REQUEST

Current Zoning: O-1(CD) (office, conditional)
Proposed Zoning: O-1(CD)SPA (office, conditional, site plan amendment)

Approximately 1.27 acres located on the north side of Ballantyne Commons Parkway, east of Rea Road
(Council District 7 - Driggs)

PLANNING STAFF REVIEW

• Proposed Request Details

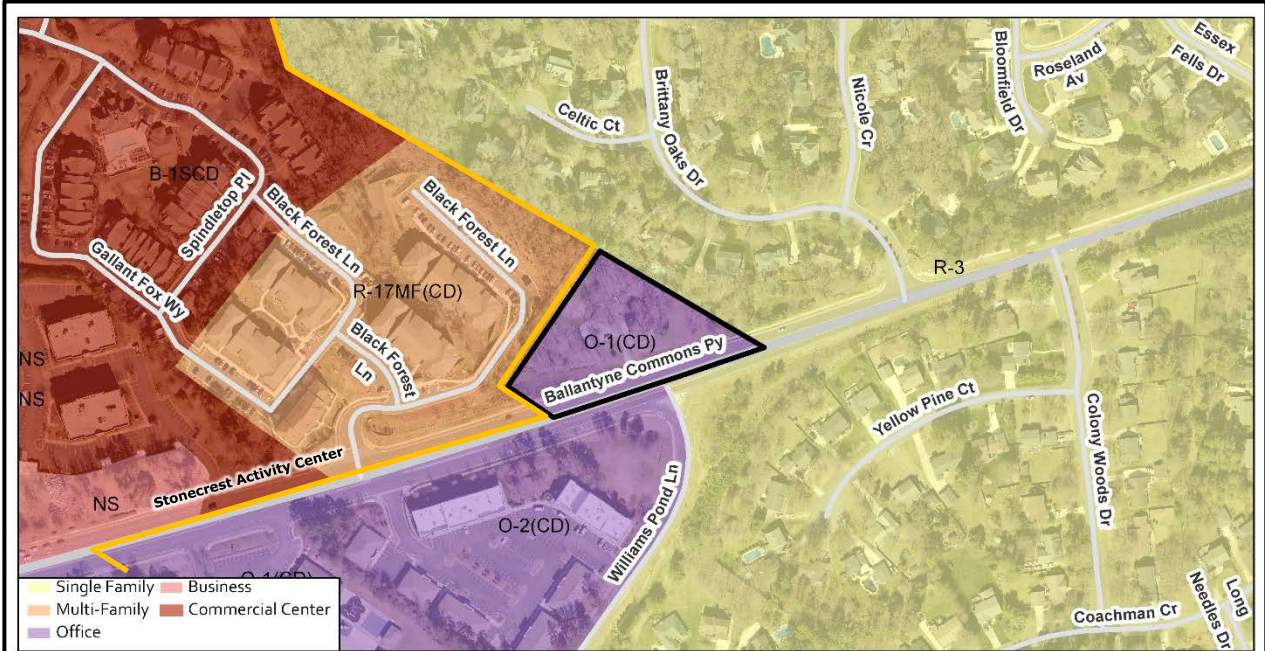
1. ~~Expand Note 7 under Architectural Guidelines to state that the entry plaza will include pedestrian amenities such as, but not limited to, seating areas, art, water features and/or specialty landscaping.~~ Addressed.

2. ~~Label the storefront entry and clear glass windows on the first floor of the building renderings.~~ Addressed.
3. ~~Amend the buffer and label along the northwest property line to provide a 12-ft wide (16 feet reduced by 25% with the screening fence) Class C buffer, rather than 10 feet as shown on the site plan. In addition, add a note under Streetscape and Landscaping that reads "A 16' Class C buffer along the northwestern property line will be reduced to 12 ft with the provision of a 6' tall screen wall."~~ Addressed.

4. ~~Amend the site plan to show a 16-foot Class C buffer along the northeastern property line rather than a 15-foot buffer. In addition, amend Note 12 to read "The 16' Class C buffer may not be reduced along the northeastern property line. A 6' tall screen wall will be provided along the northeastern property line."~~ Addressed, additionally the petitioner increased the height of the screen wall along the northeast property line to 10 feet.

5. ~~Add a note under Streetscape and Landscaping that states "Petitioner agrees to provide an eight foot planting strip behind the future back-of-curb along Ballantyne Commons Parkway."~~ Addressed.

6. ~~Update the site plan to show two feet of right-of-way behind the sidewalk or show a two-foot easement behind sidewalk.~~ Addressed, the petitioner added an easement two-feet behind the sidewalk.

8. ~~Amend Note 6 under architectural guidelines to correct the spelling of Ballantyne Commons Parkway, amend Note 17 under Transportation to correct the spelling of crossover, and change the word "designated" to "designed" in Note 18 under Transportation.~~ Addressed.

9. ~~Indicate the distance the future curb is from the centerline of Ballantyne Commons Parkway.~~ Addressed, staff rescinded this comment and asked the petitioner to show and label the existing right-of-way. The proposed zoning has setbacks based on the right-of-way rather than the back-of-curb.

10. ~~Amend Note 10 under Streetscape and Landscaping to change the setback from 20 feet to 30 feet as shown on the site plan.~~ Addressed.
11. ~~Change the label for "large maturing trees" to "required street trees."~~ Addressed.

12. ~~Delete the last sentence of Note 10 under Streetscape and Landscaping because street trees are regulated by the Tree Ordinance.~~ Addressed.
